**ZONING AMENDMENT  
& SUBDIVISION STAFF REPORT****Date: February 18, 2016****APPLICANT NAME**

New Life Housing, LLC

**LOCATION**3901 Cottage Hill Road  
(South side of Cottage Hill Road, 25'± West of Hawthorne Drive)**CITY COUNCIL  
DISTRICT**

# SITE PLAN

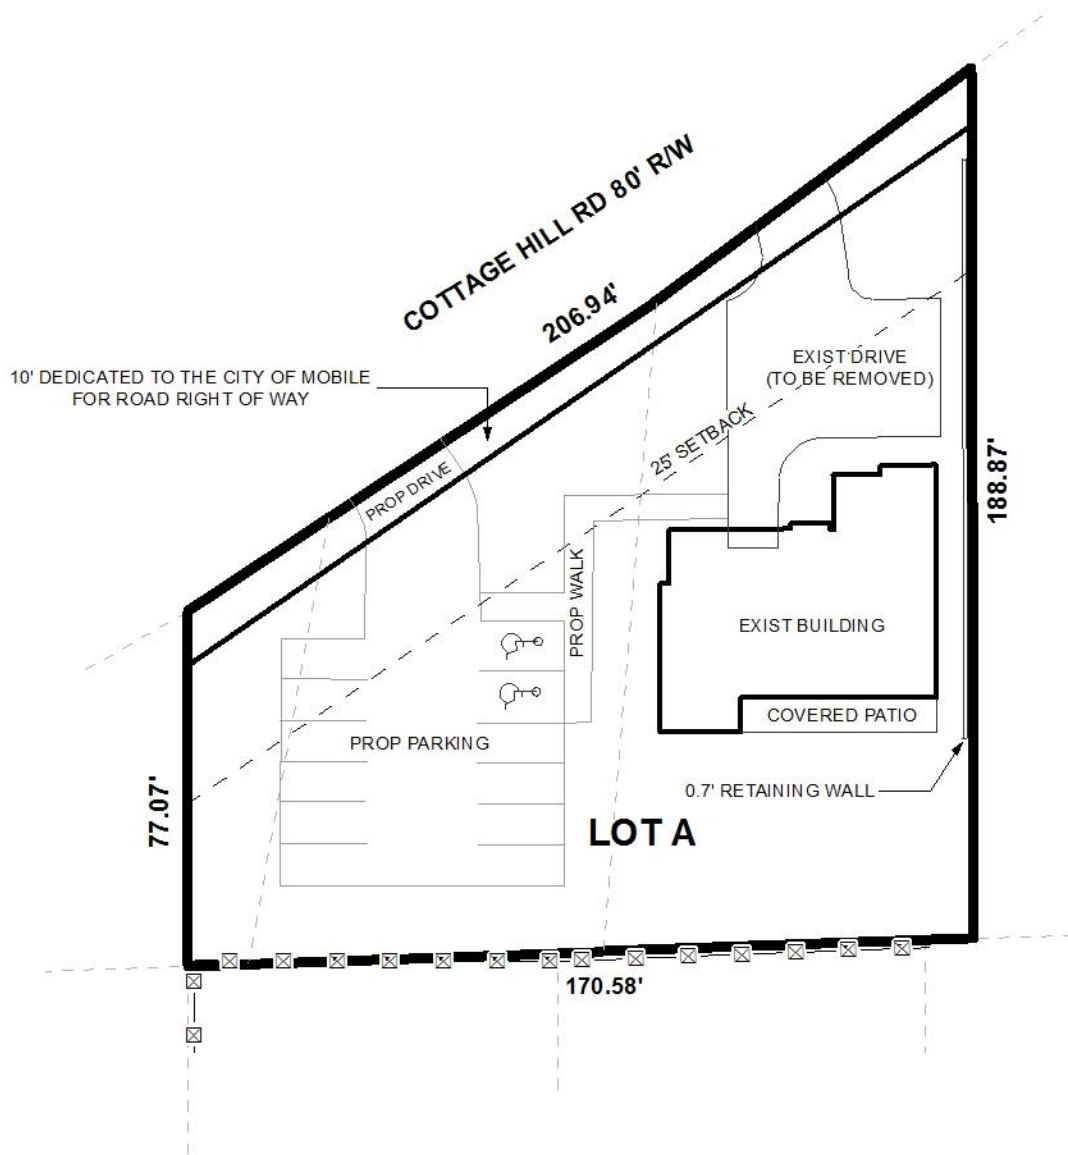
*The site plan submitted indicates a compliant 24' driveway and parking access aisle, and sufficient parking spaces for the proposed use. Only the total landscaping area required is calculated, but it is erroneous. No indication of required buffering along adjacent residential*

*properties is indicated. With the possible dedication of frontage along Cottage Hill Road required by the accompanying Subdivision, the site may not have sufficient area remaining along Cottage Hill Road to meet the frontage landscaping requirements.*

*The applicant submitted a revised site plan indicating the frontage right-of-way dedication area required by the Subdivision and a relocated curb cut and drive to the parking area with the existing curb cut and frontage parking area proposed to be removed. The revised entrance and parking would allow for an easier access and maneuvering area than previously proposed and would also allow for compliant frontage landscaping. It should also be noted that if the Zoning request is approved and the project moves forward, a sidewalk will be required along Cottage Hill Road.*

- 1) *dedication sufficient to provide 50' from the centerline of Cottage Hill Road;*
- 2) *placement of a note on the Final Plat stating that the lot is limited to one curb cut to Cottage Hill Road, with the size, location and design to be approved by Traffic Engineering and conform to AASHTO standards;*
- 3) *revision of the plat to indicate the 25' minimum building setback line as measured from any required frontage dedication;*
- 4) *revision of the plat to label the lot size in both square feet and acres after any required frontage dedication, or the furnishing of a table on the Final Plat providing the same information;*
